ADDENDUM NO. CC-1

TELEGRAPH DISTRICT
401 BUILDING RENOVATION
LINCOLN, NEBRASKA
DLR GROUP PROJECT NO. 10-16202-00

February 26, 2016

2 ENLARGED EAST ELEVATOR PLAN
E4.1 SCALE: 1/4" = 1'-0"

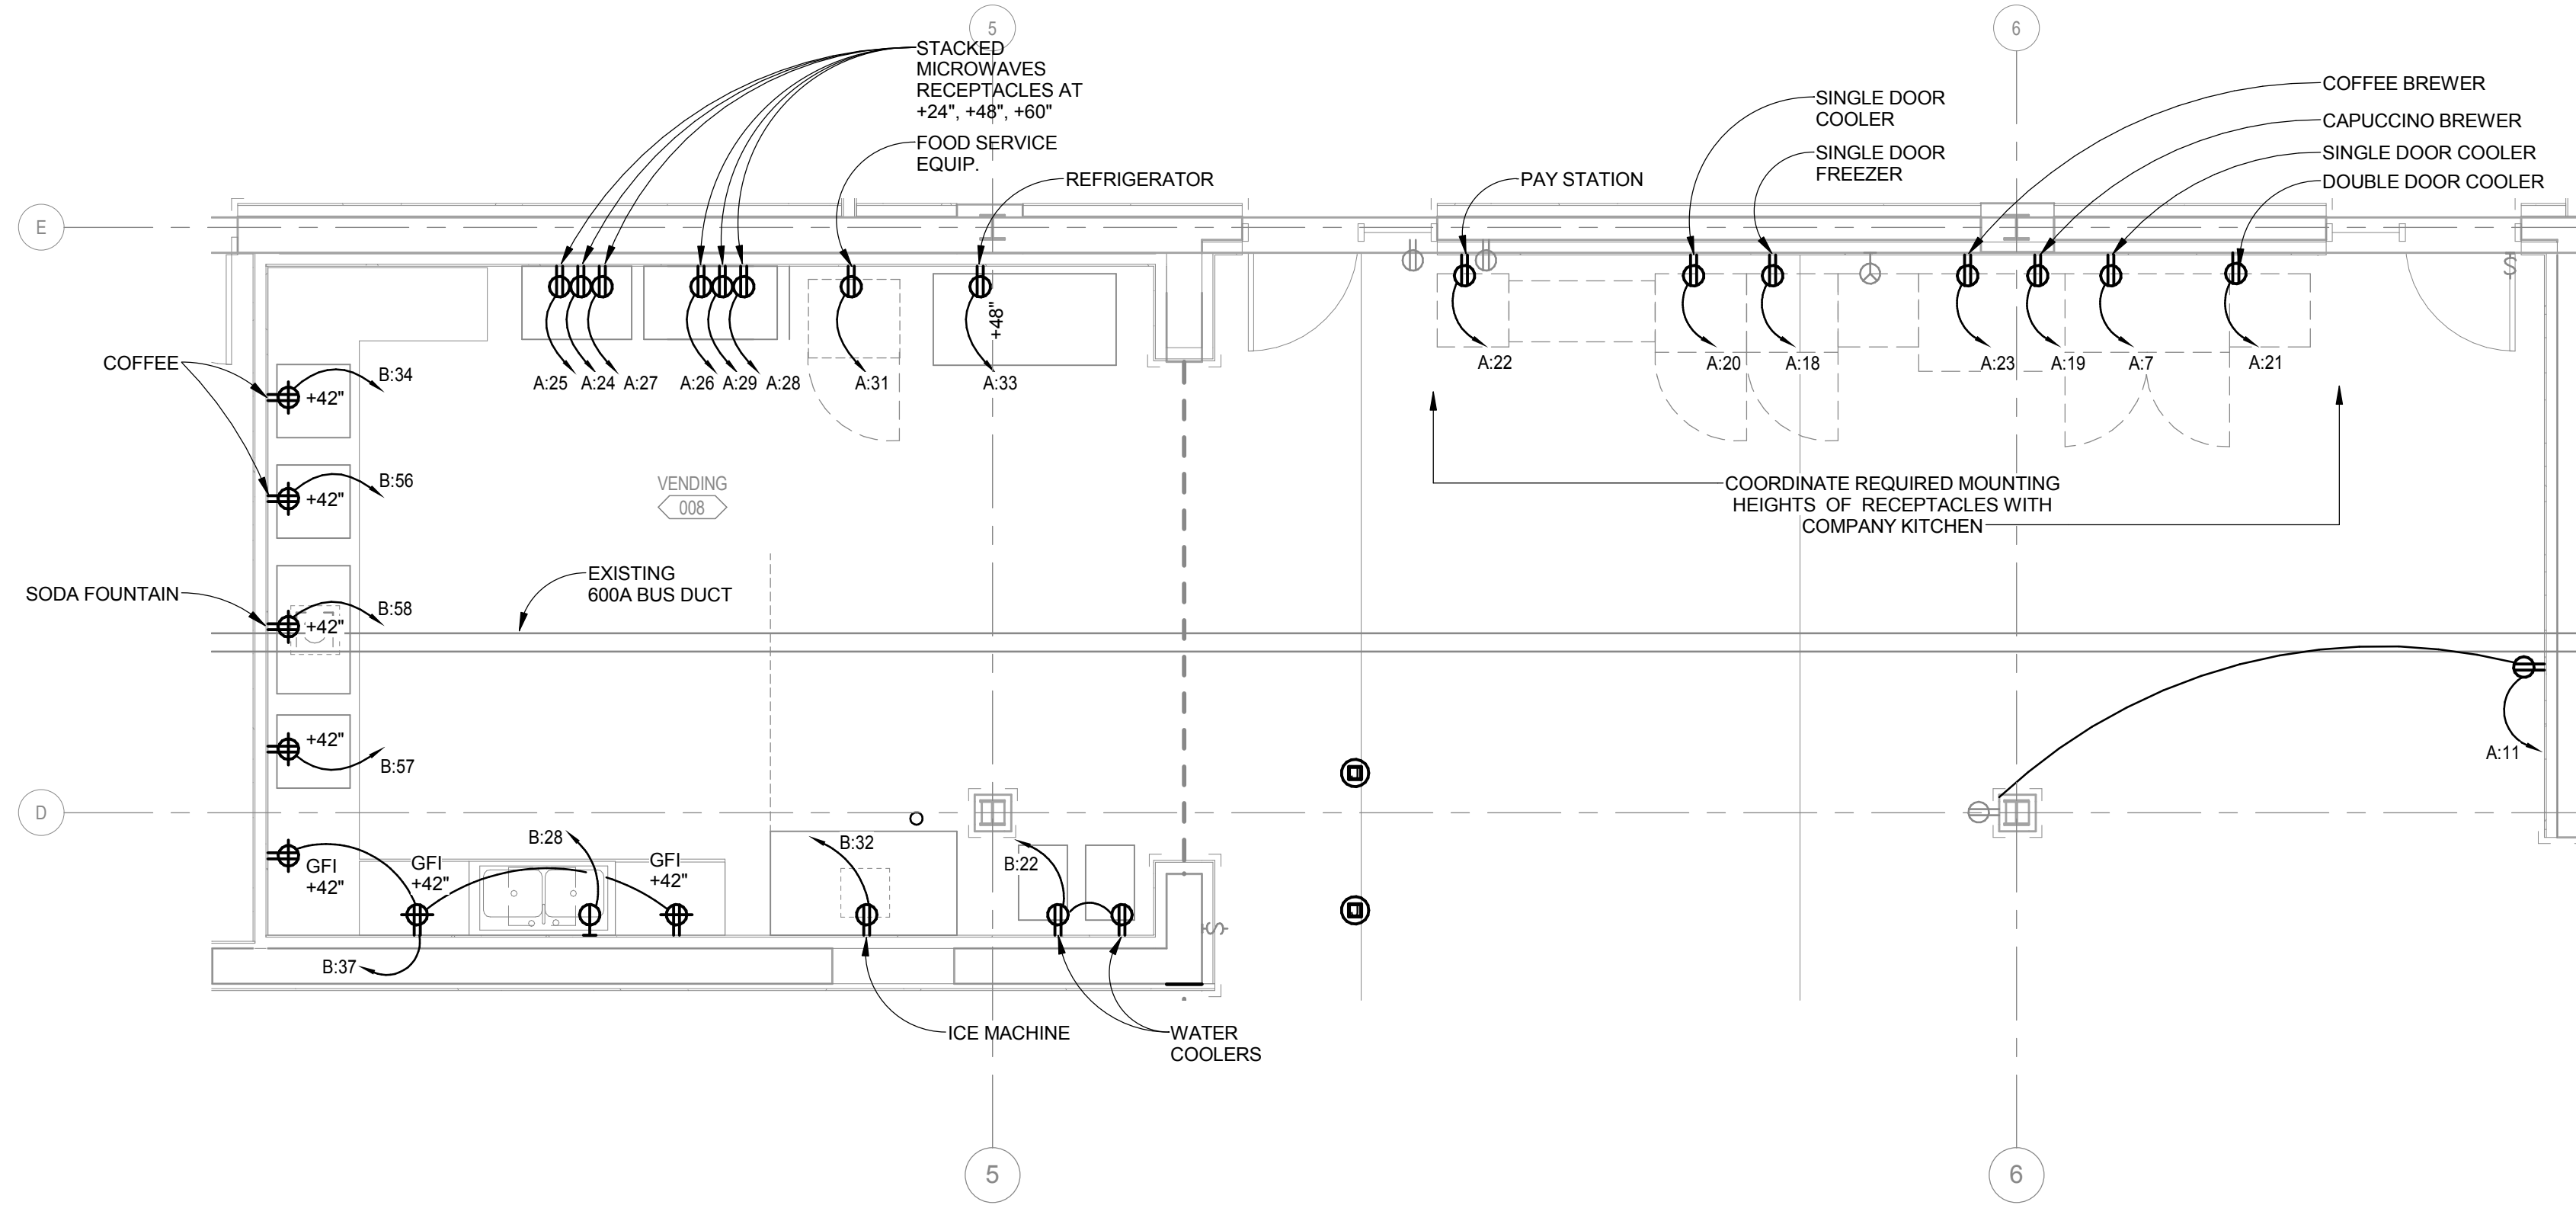
- A. Revise Detail 1 for the West Elevator Plan as shown in attached drawing E4.1.
B. Revise Detail 2 for the East Elevator Plan as shown in attached drawing E4.1
C. Revise Detail 4 for the Enlarged Penthouse Plan as shown in attached drawing E4.1.
